## **Stag Brewery, Mortlake Amended Scheme**

### **Drainage Strategy Addendum**

# Surface Water Drainage Update Briefing Note

Stag Brewery – Response to GLA Comments received 25 October 2018

Title: **PROPOSED FOUL AND SURFACE WATER DRAINAGE LAYOUT SHEET 2 OF 4**

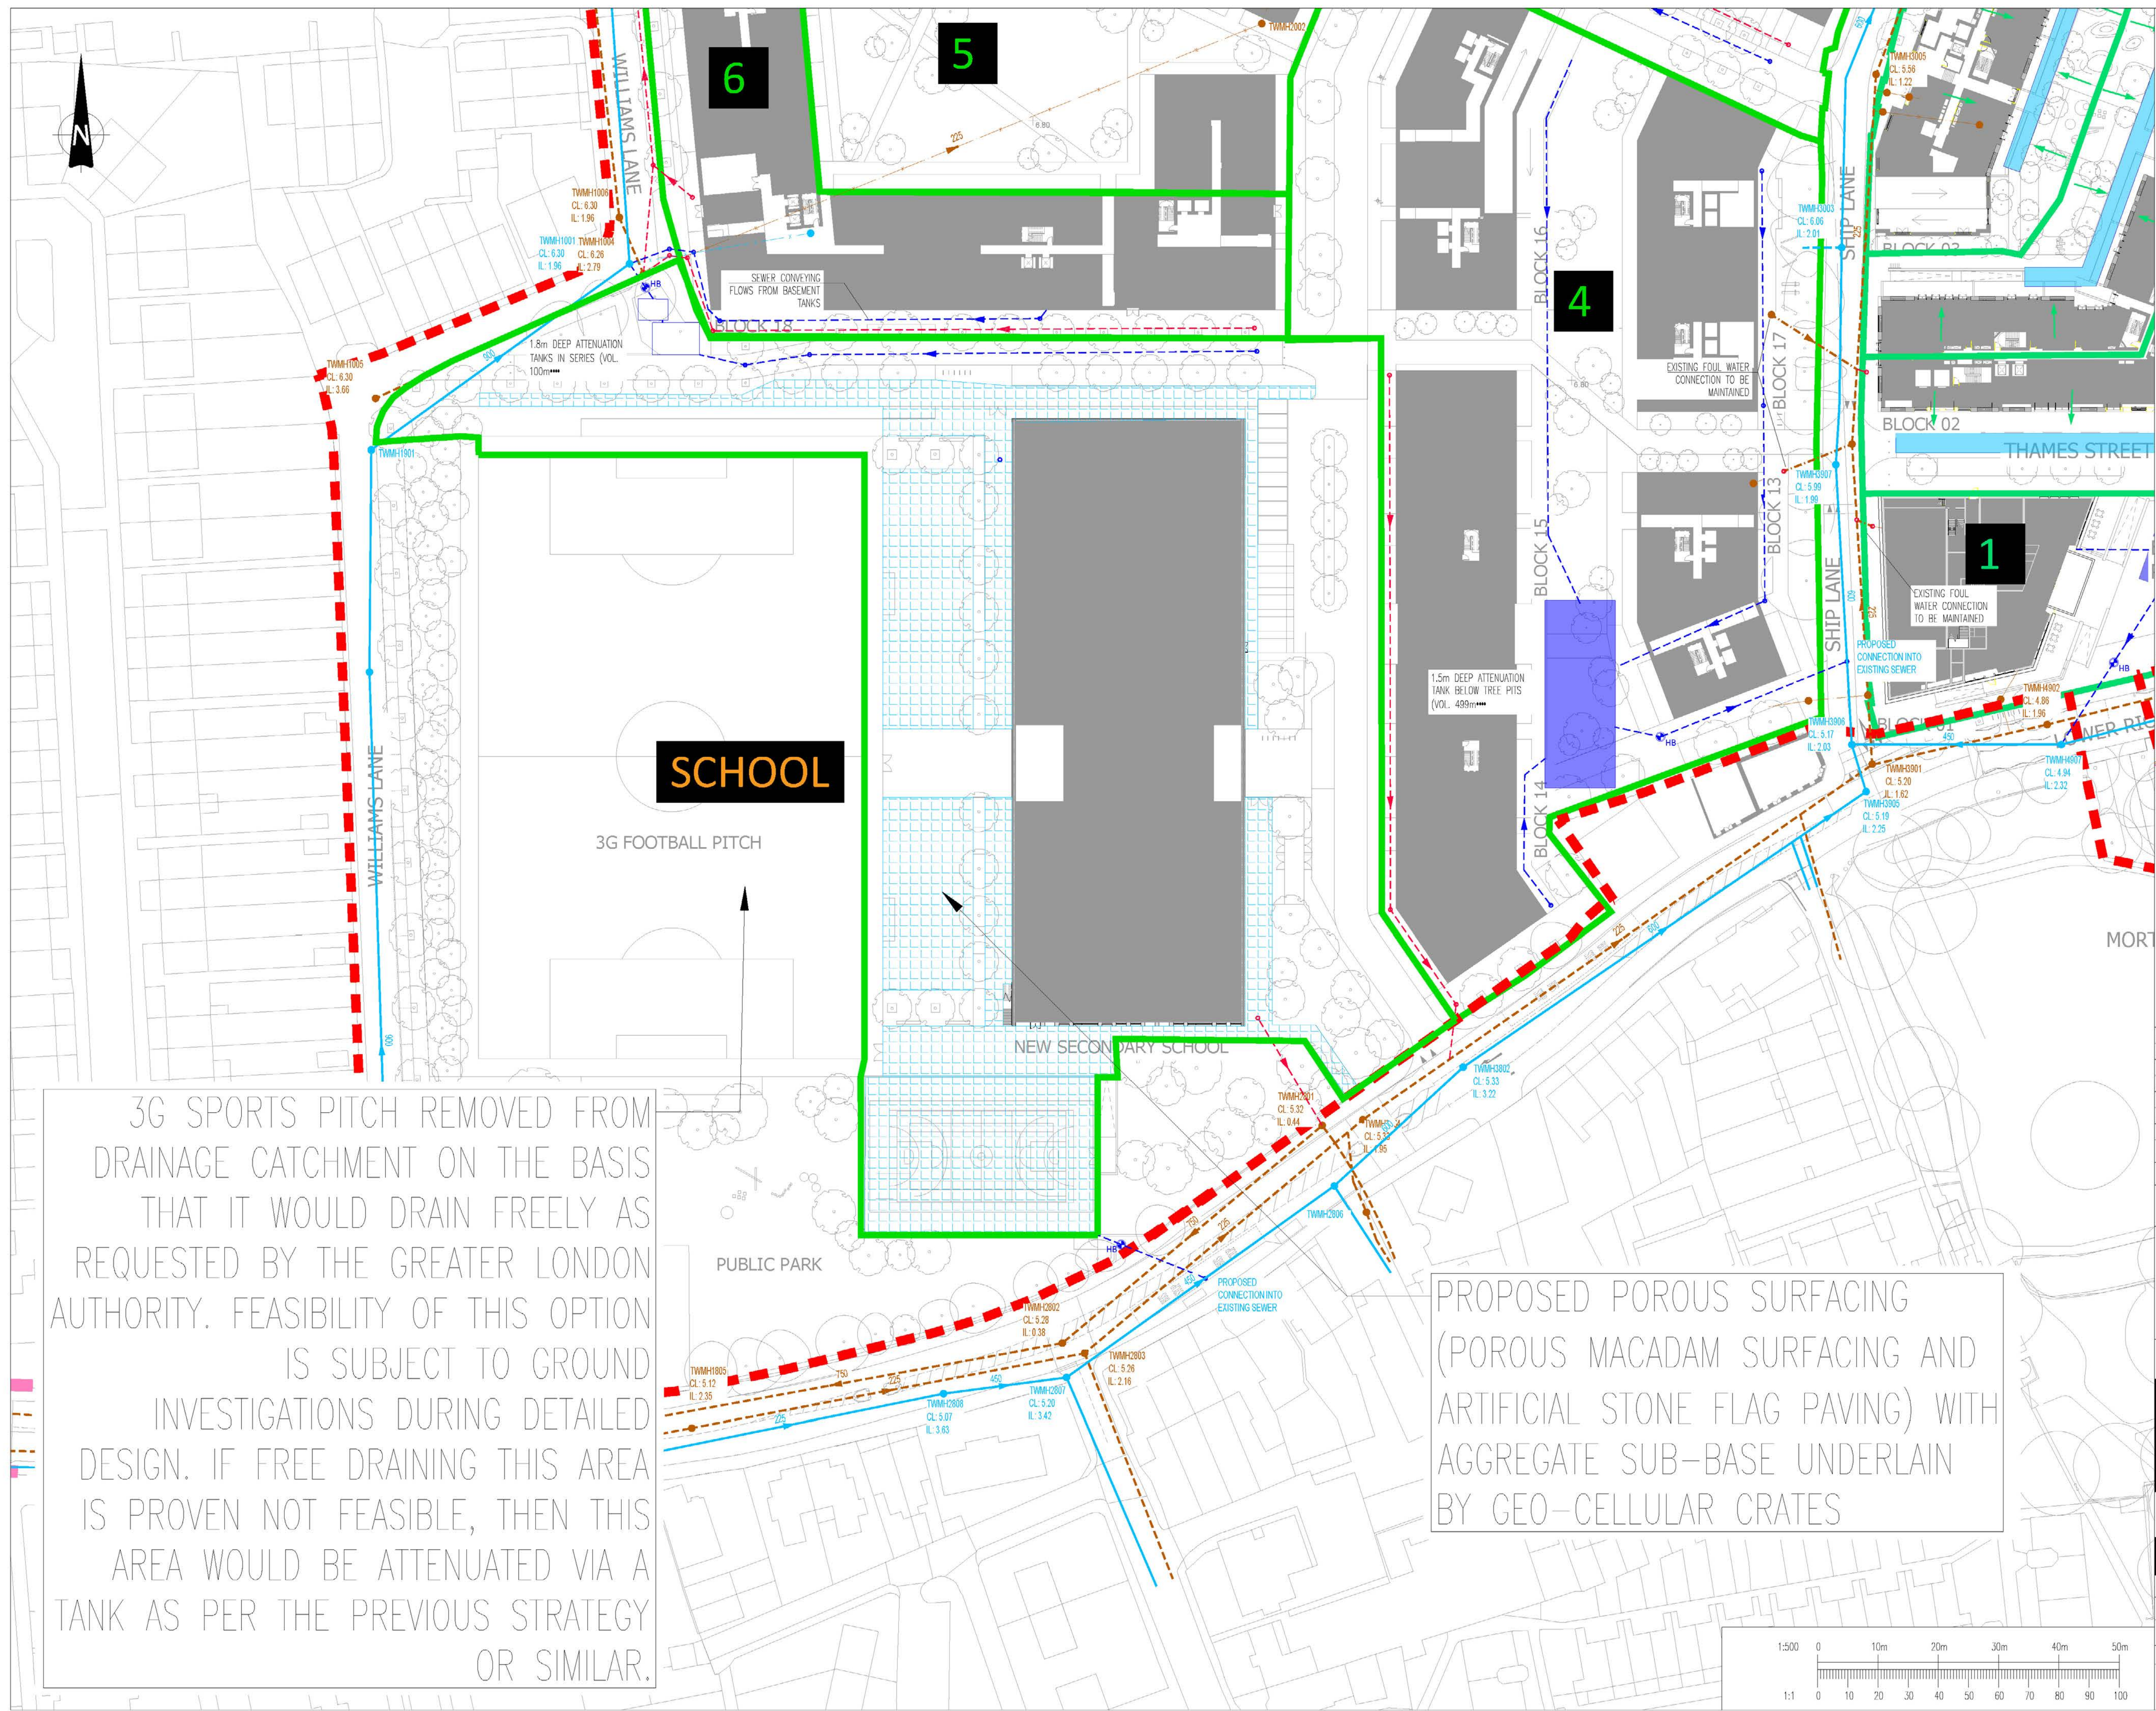
3G SPORTS PITCH REMOVED FROM DRAINAGE CATCHMENT ON THE BASIS THAT IT WOULD DRAIN FREELY AS REQUESTED BY THE GREATER LONDON AUTHORITY. FEASIBILITY OF THIS OPTION IS SUBJECT TO GROUND INVESTIGATIONS DURING DETAILED DESIGN. IF FREE DRAINING THIS AREA IS PROVEN NOT FEASIBLE, THEN THIS AREA WOULD BE ATTENUATED VIA A TANK AS PER THE PREVIOUS STRATEGY OR SIMILAR.

PROPOSED POROUS SURFACING (POROUS MACADAM SURFACING AND ARTIFICIAL STONE FLAG PAVING) WITH AGGREGATE SUB-BASE UNDERLAIN BY GEO-CELLULAR CRATES

**Title**  
PROPOSED FOUL AND SURFACE WATER DRAINAGE LAYOUT SHEET 3 OF 4

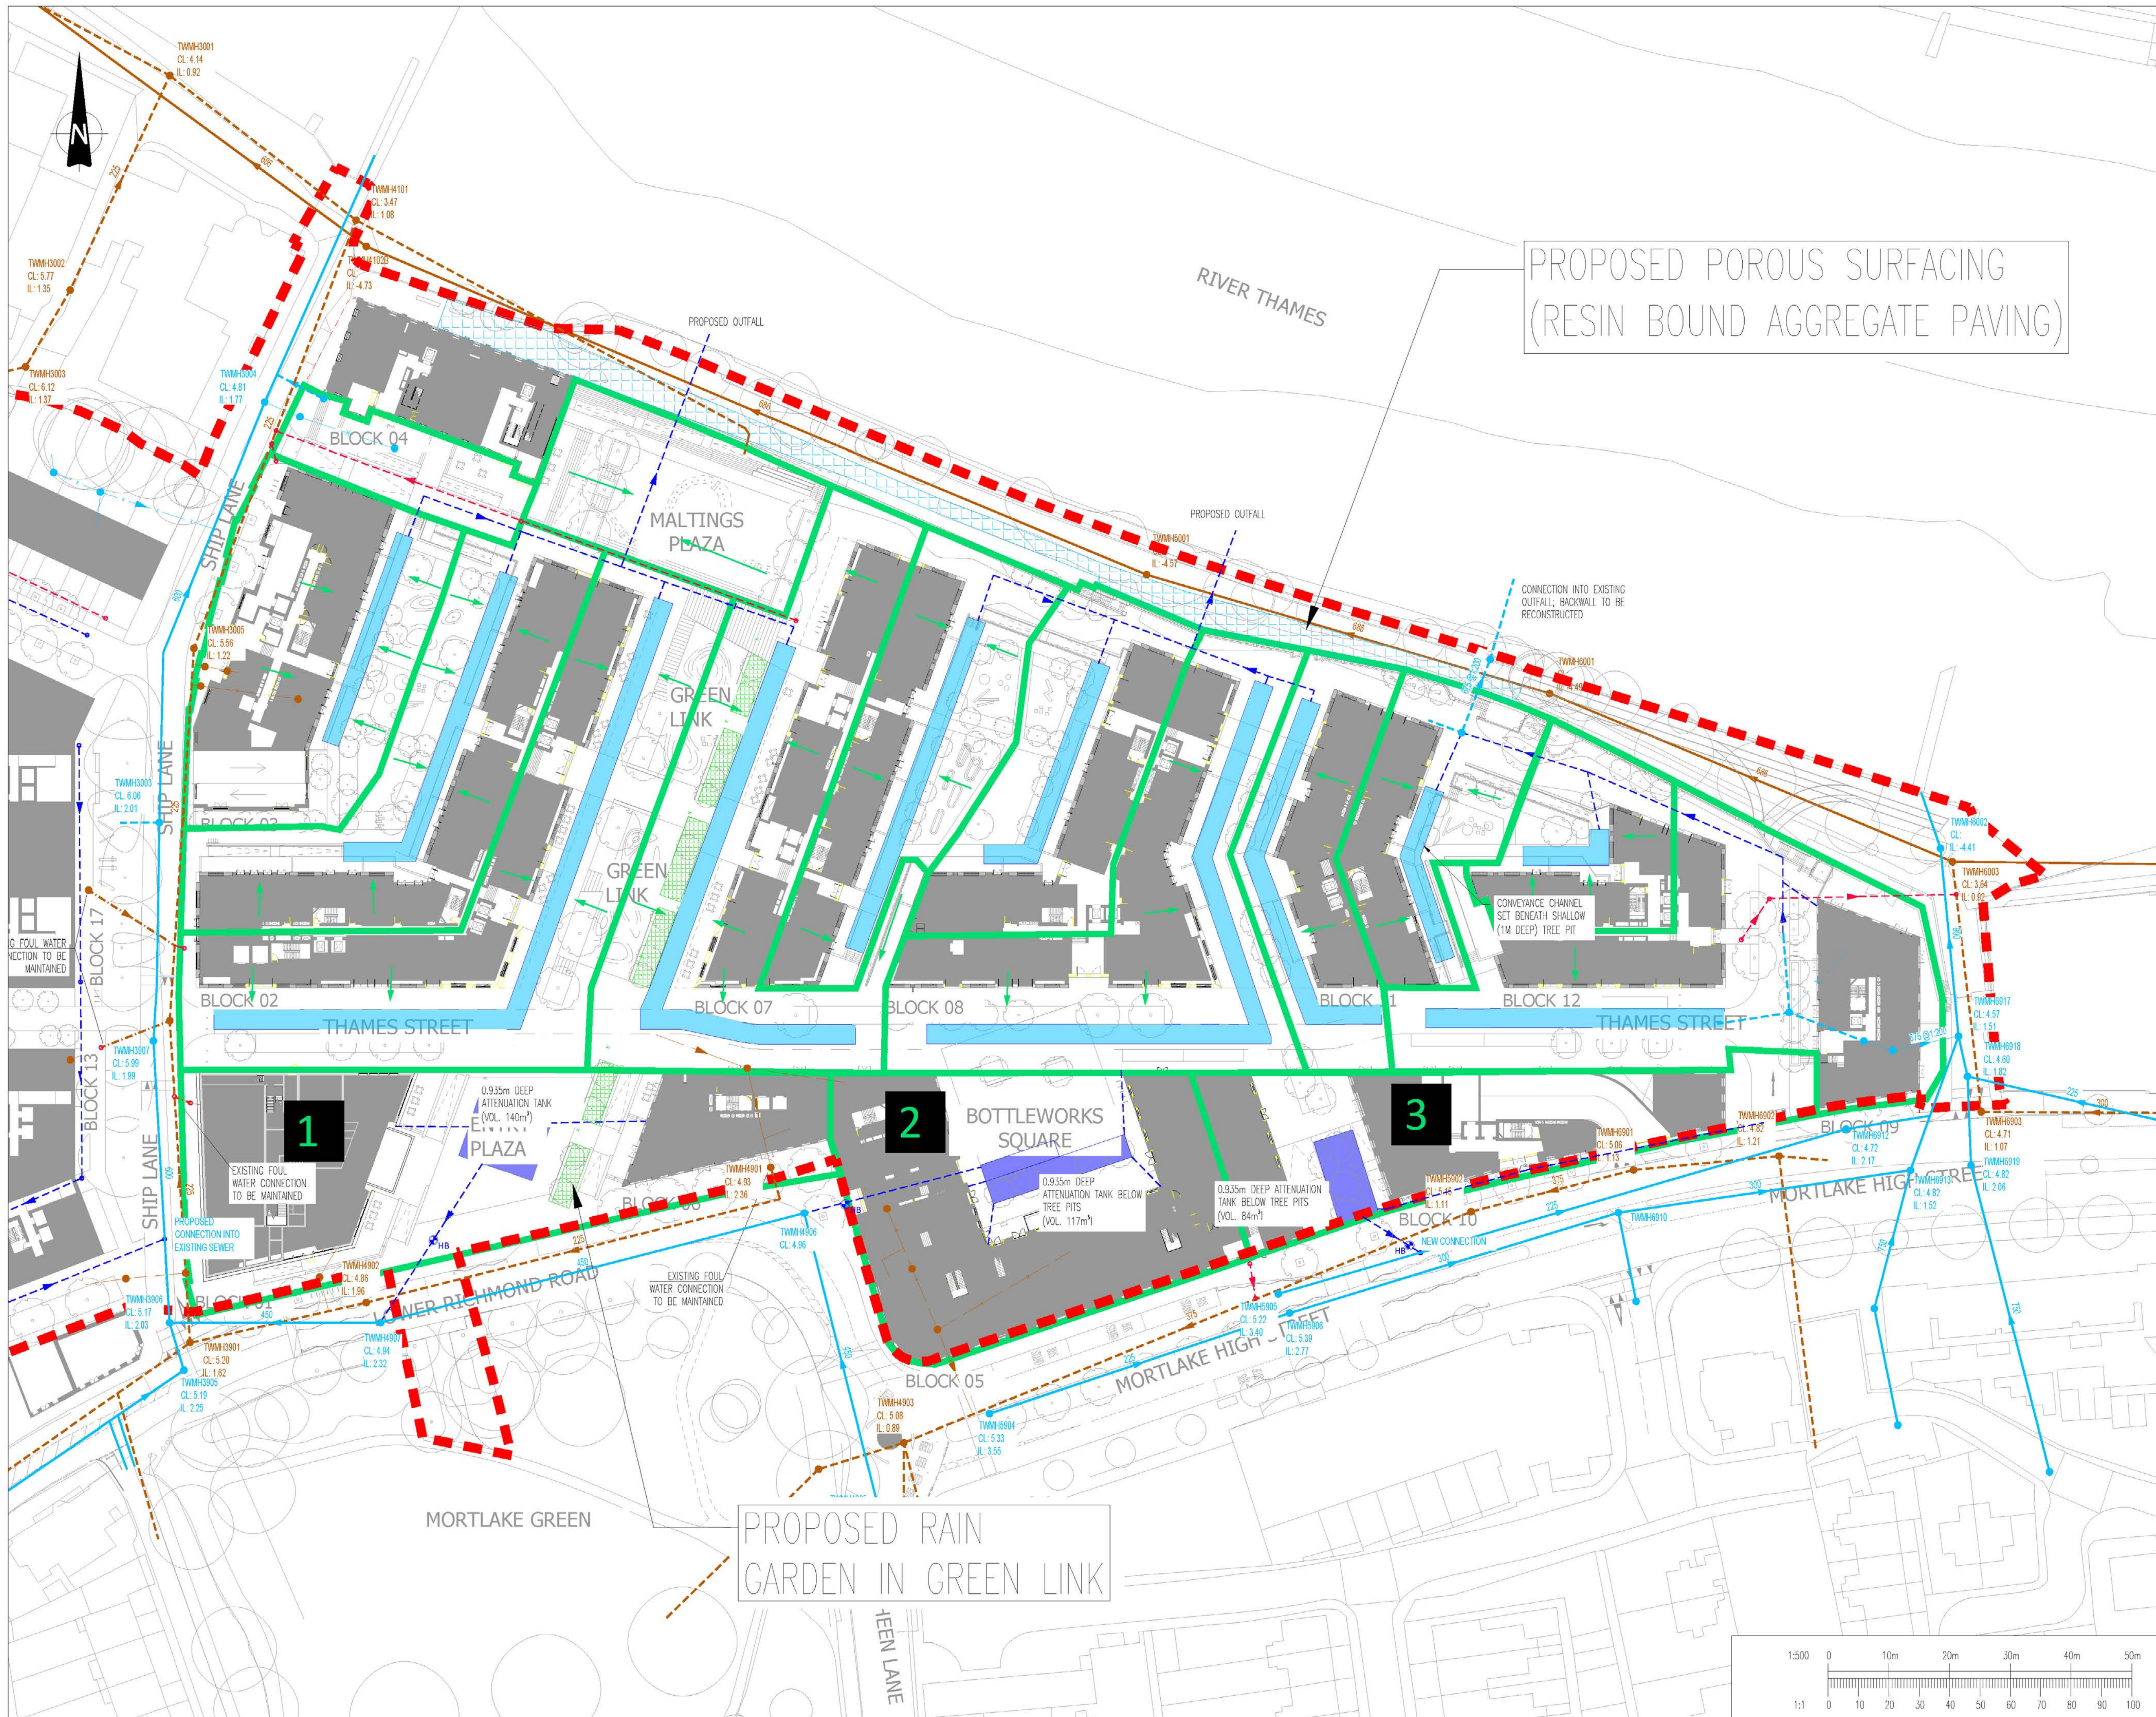
<p>The area of site draining directly to the River Thames seems to ignore the presence of the proposed public realm and in particular the "Green Link" (ref Drainage Layout Sheet 3). The surface water drainage should be integrated within these elements with surface water directed across the surface rather than proposing a large array of permavoid cells to convey the surface water underground. This will not only provide a whole host of benefits to the public realm but will also help to improve the water quality of the surface water if managed by nature based SuDS solutions. The reference to potential contaminated land issues seems to have been used as thinly veiled excuse and is unlikely to be a barrier to above ground SuDS. At present the proposal makes no reference to water quality when it really should do given that it is</p>	<p>The applicant has provided justification as to why it would not be feasible to direct all surface water to rain gardens but does not consider other greener conveyance features. The applicant has highlighted where water quality is considered in the drainage strategy however some measures are described as 'potential'. It is recommended that clear demonstration of water quality in the final design is conditioned.</p>	<p>The main green link (i.e. rain garden) is located in the eastern part of the Stag Brewery site, running from Lower Richmond Road north eastwards towards the River Thames, as per the Landscape DAS (reference: P10736-00-001). The rain garden would channel and treat runoff as it is conveyed towards the River Thames. However, due to levels, it is not feasible to direct all surface water from this part of the site into the green link. As a result, a network of shallow geo-cellular storage conveyance channels is proposed. These would convey and treat runoff (via pollutant-intercepting biomats within the tanks) prior to discharging into the Thames. There are a large number of planters proposed across the site, which would allow surface water runoff to filter through the soil providing treatment, prior to discharge into the geo-cellular conveyance channels and eventually the River Thames.</p>

<p>The area of site draining directly to the River Thames seems to ignore the presence of the proposed public realm and in particular the “Green Link” (ref Drainage Layout Sheet 3). The surface water drainage should be integrated within these elements with surface water directed across the surface rather than proposing a large array of permavoid cells to convey the surface water underground. This will not only provide a whole host of benefits to the public realm but will also help to improve the water quality of the surface water if managed by nature based SuDS solutions. The reference to potential contaminated land issues seems to have been used as thinly veiled excuse and is unlikely to be a barrier to above ground SuDS. At present the proposal makes no reference to water quality when it really should do given that it is proposing discharging into a waterbody.</p>	<p>Water quality is considered within the drainage strategy, paragraph 4.32. For the section of the site discharging into the River Thames (east of Ship Lane), there are a number of SuDS proposed which would treat runoff prior to discharge. These include the rain garden, planters, and the potential for permeable paving adjacent to the Thames. In addition to the biomats within the shallow geo-cellular tanks within the podium build-up, a downstream defender can be incorporated if found necessary, to be confirmed during detailed design.</p> <p>It would be unfeasible to direct all surface water runoff from this part of the development into the rain gardens within the green link. Due to the depth of build up above the ground floor slab the distance drainage can run in this zone is limited, hence why the shallow geo-cellular conveyance channels are provided adjacent to the</p>

- 2.7. As per the Landscape Design and Access Statement by Gillespies<sup>1</sup>, a green link is proposed in the eastern part of the Stag Brewery component of the Site. A rain garden is proposed along the eastern edge of the green link (Appendix C). Surface water runoff from the surrounding pavement would be directed into the soil within the rain garden. The rain garden has been added to the surface water drainage strategy drawing (Appendix B).

PROPOSED RAIN GARDEN IN GREEN LINK
